775 RICHARDS STREET (COMPLETE APPLICATION)
DE415286 - ZONE CD-1 (Pending)

DEVELOPMENT PERMIT STAFF COMMITTEE MEMBERS

DEVELOPMENT PERMIT STAFF COMMITTEE RECOMMENDATION: APPROVE

LEVEL 1 & 1 MEZZANINE
PLANS

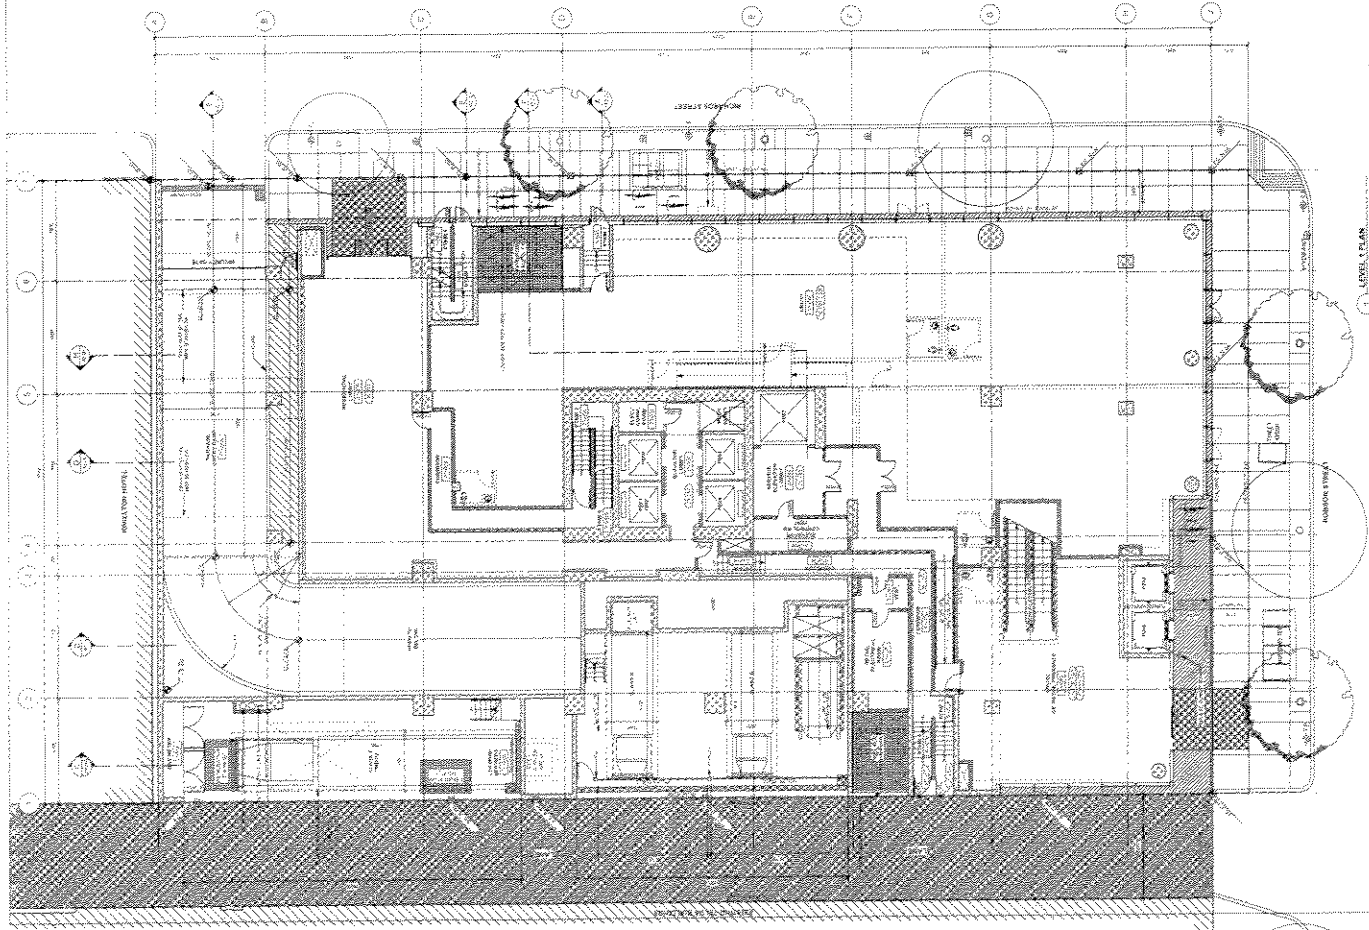
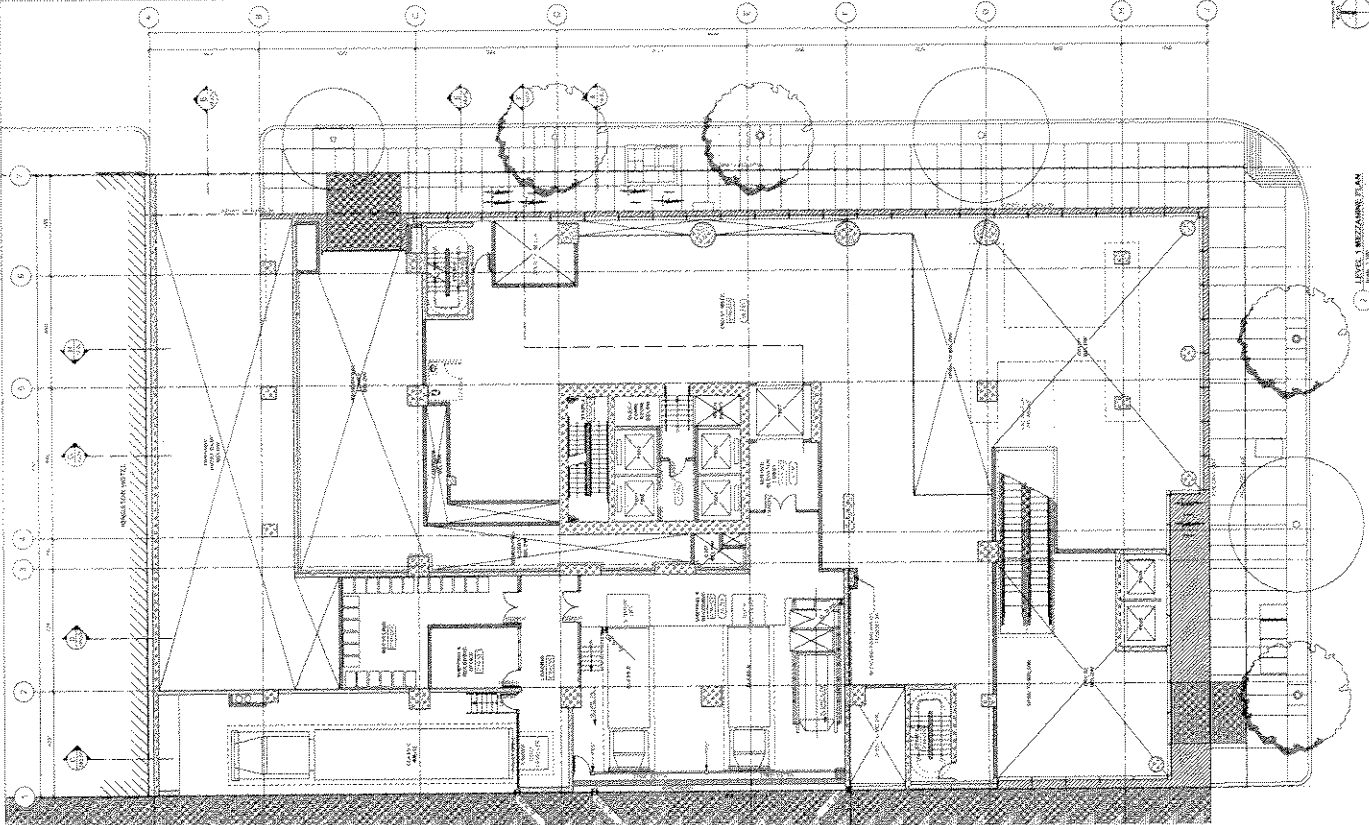
2. At Level 1, the plans do not clearly show that there is a separation of exit stair 1 from exit stair 5, and between exit stair 2 and exit stair 6, as required by the security requirements of Sentence 3.3.6.7.(3) of the Building By-law which requires that exit stairs serving the storage garage terminate at this level.

3. The two separate Fire Department siamese connection locations would seem to indicate that there are two Fire Department response points for this building at the Level 1 floor plan. The 775 Richards Street address is the response point for the residential lobby and there is a separate response point at Robson Street for the Level 1 thru Level 3 CRU suites. It is recommended that the applicant speak directly to the Fire Department to obtain their input and assessment of the proposed Fire Department response points and access to the building.

A1.06

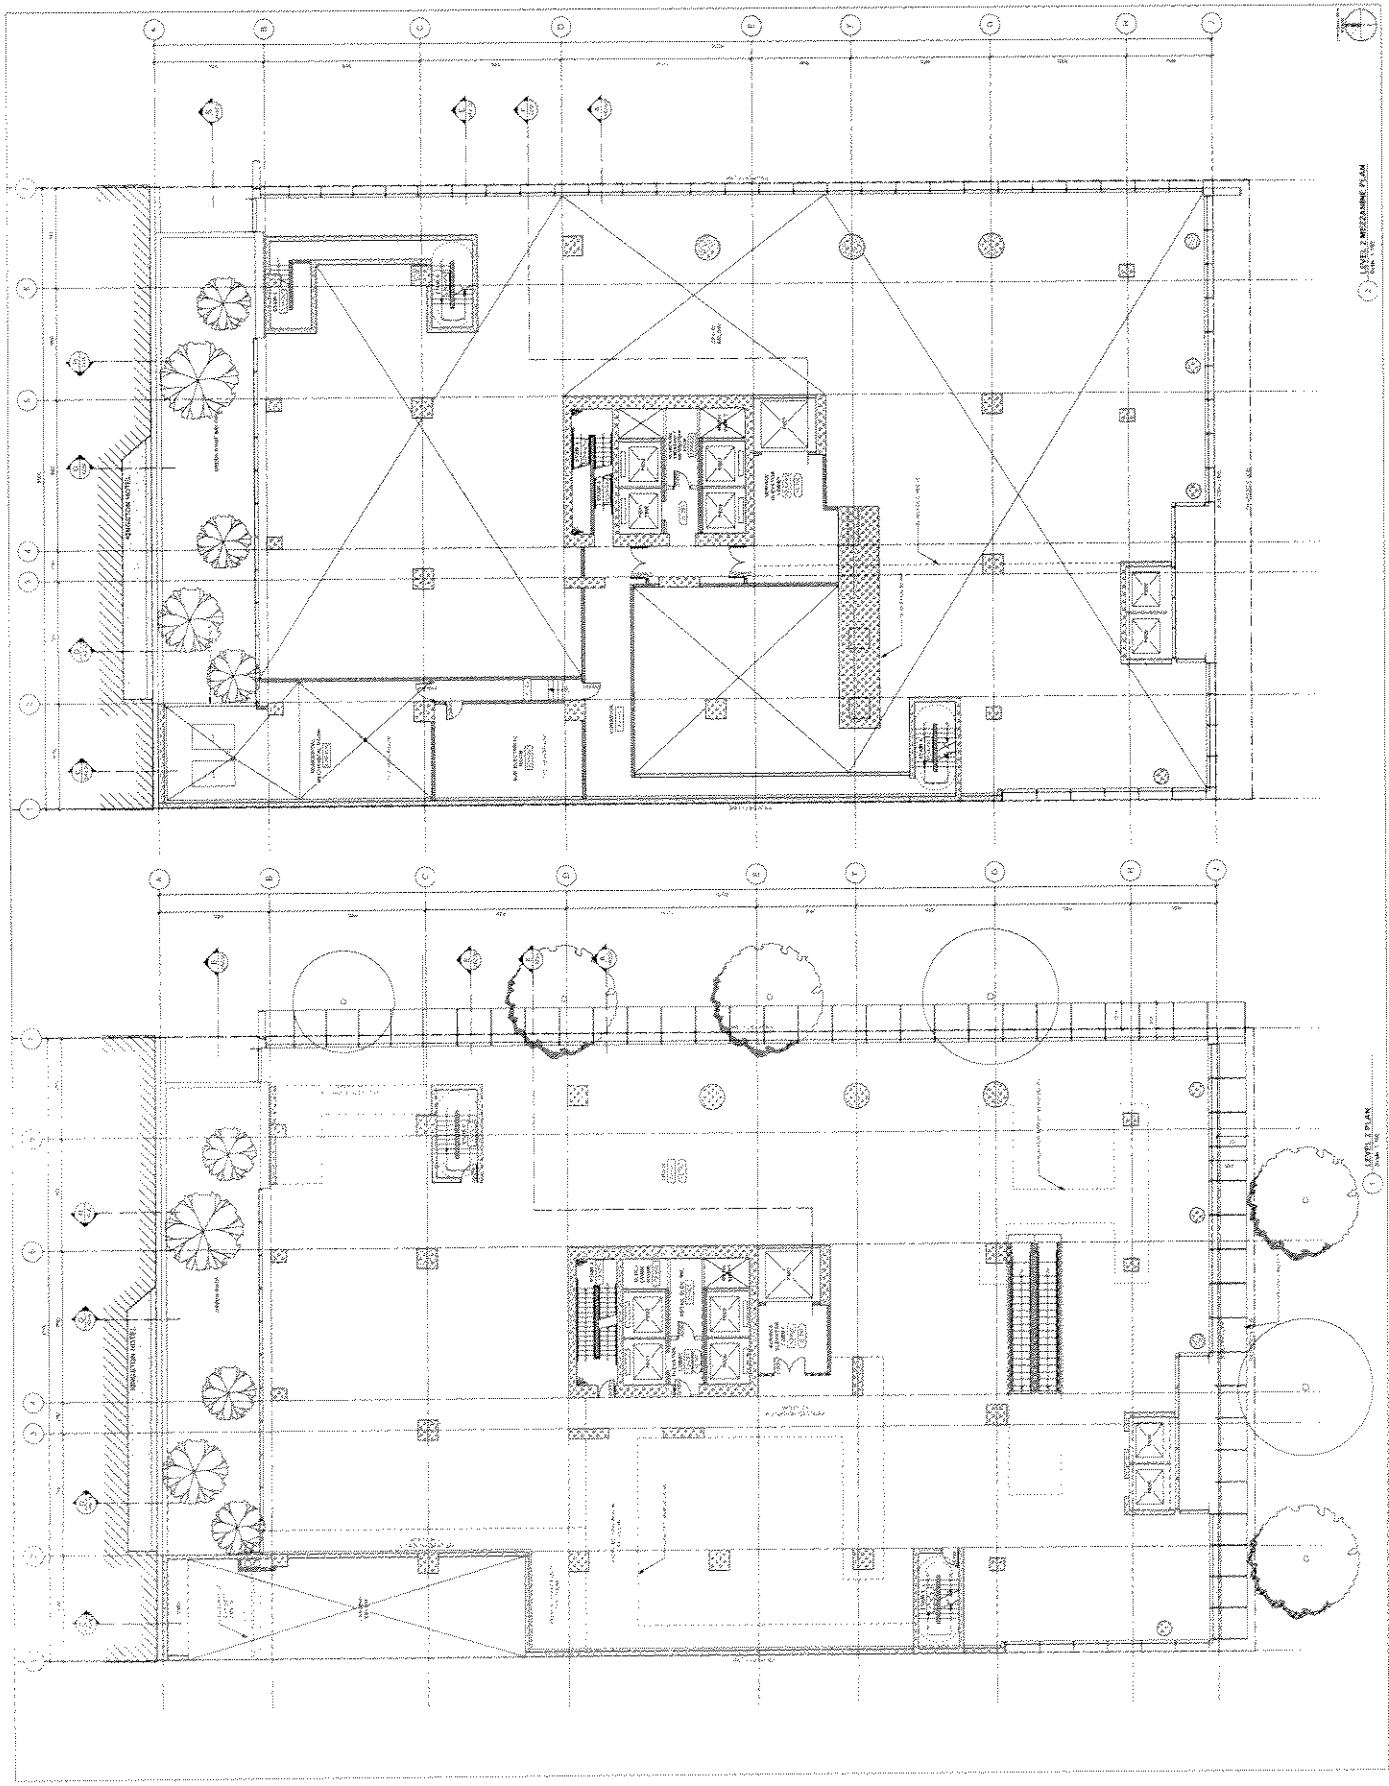
Note to Applicant: There are large vertical signs at the 2nd and 3rd levels at the Southeast and northeast corners over the Robson Street Building line, and the 2.4 m statutory right of way (sheet A1.06).

A1.07

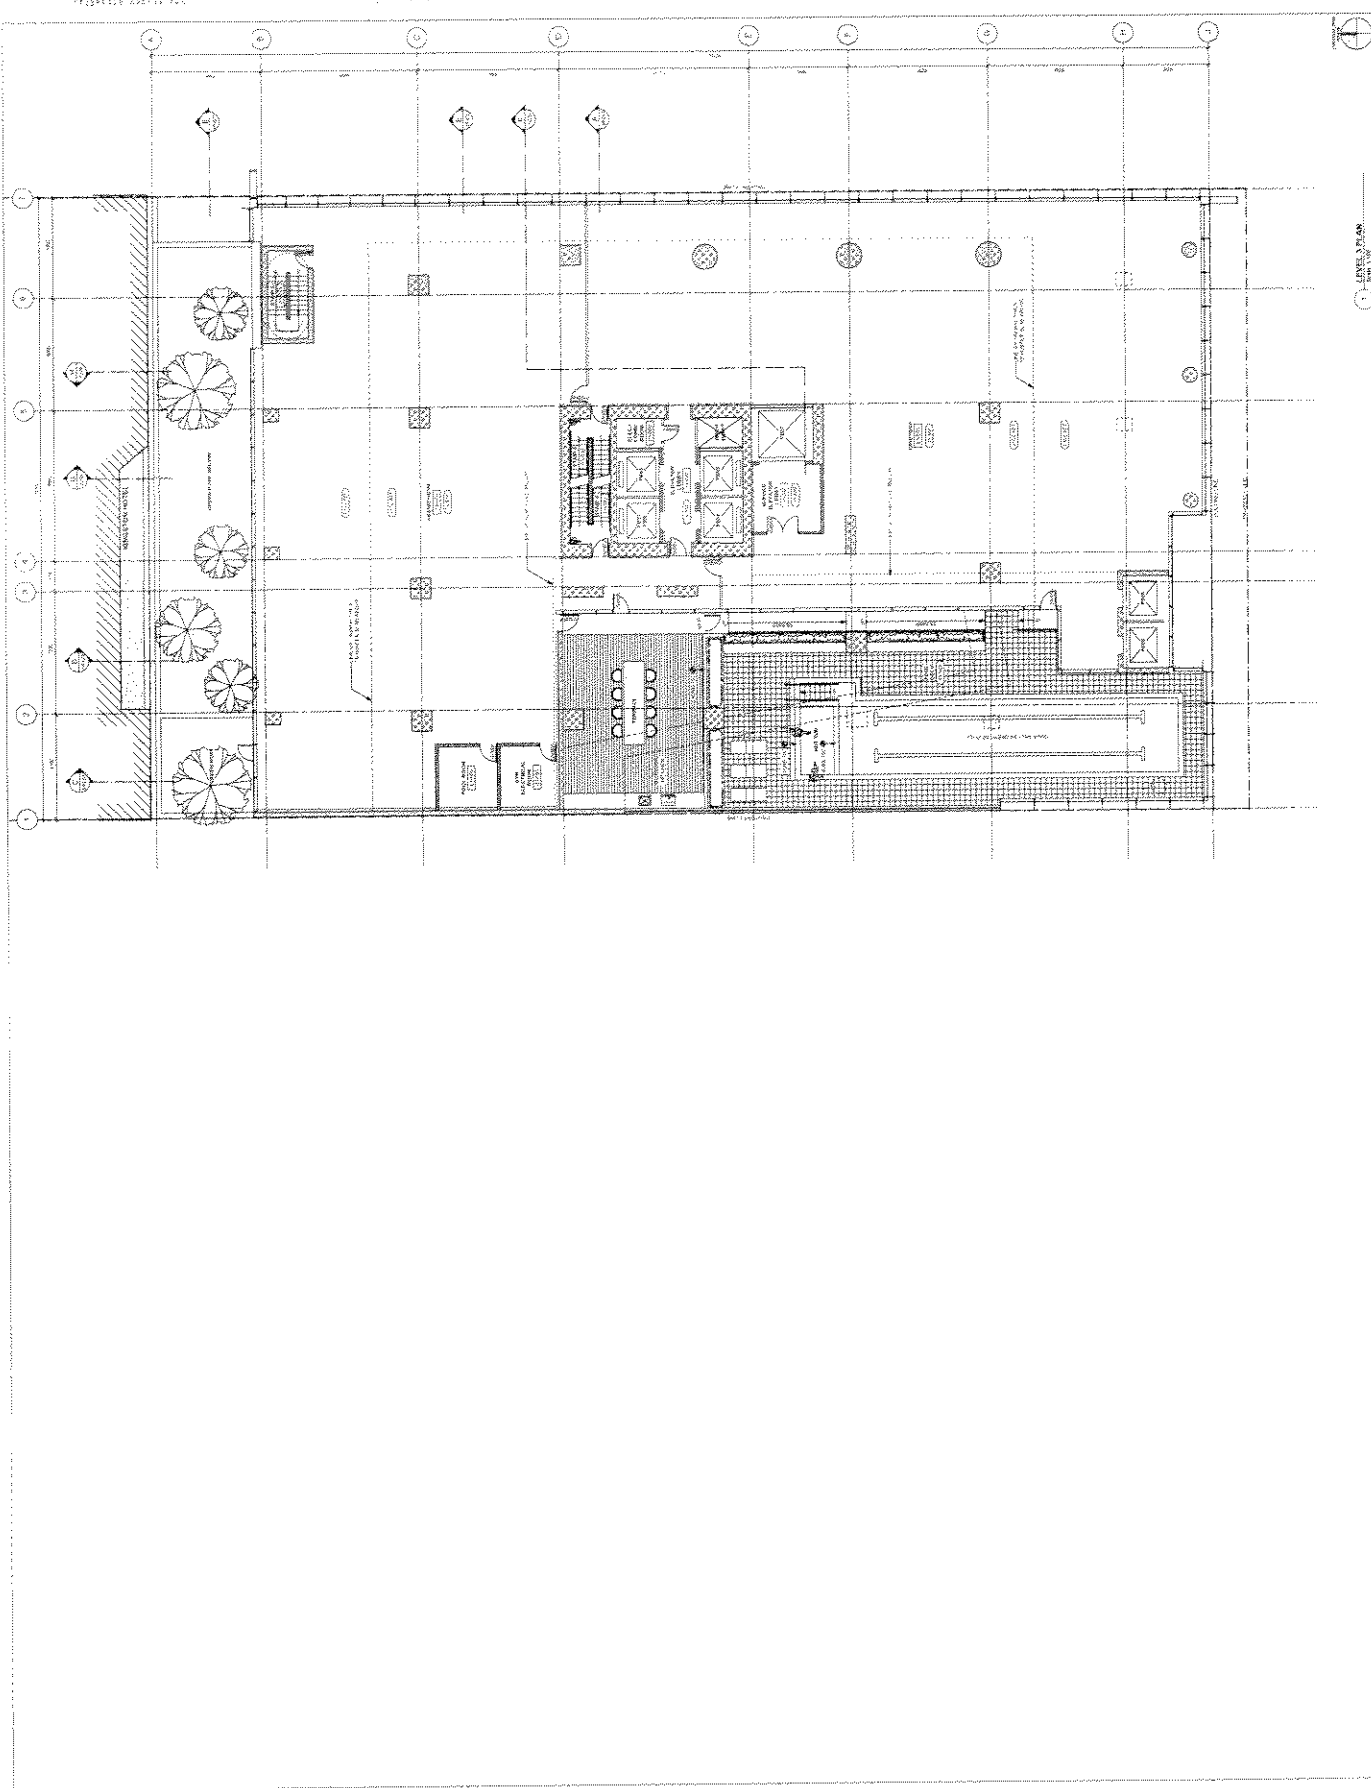
Note to Applicant: See sheet A1.07 at the southwest corner of the development.
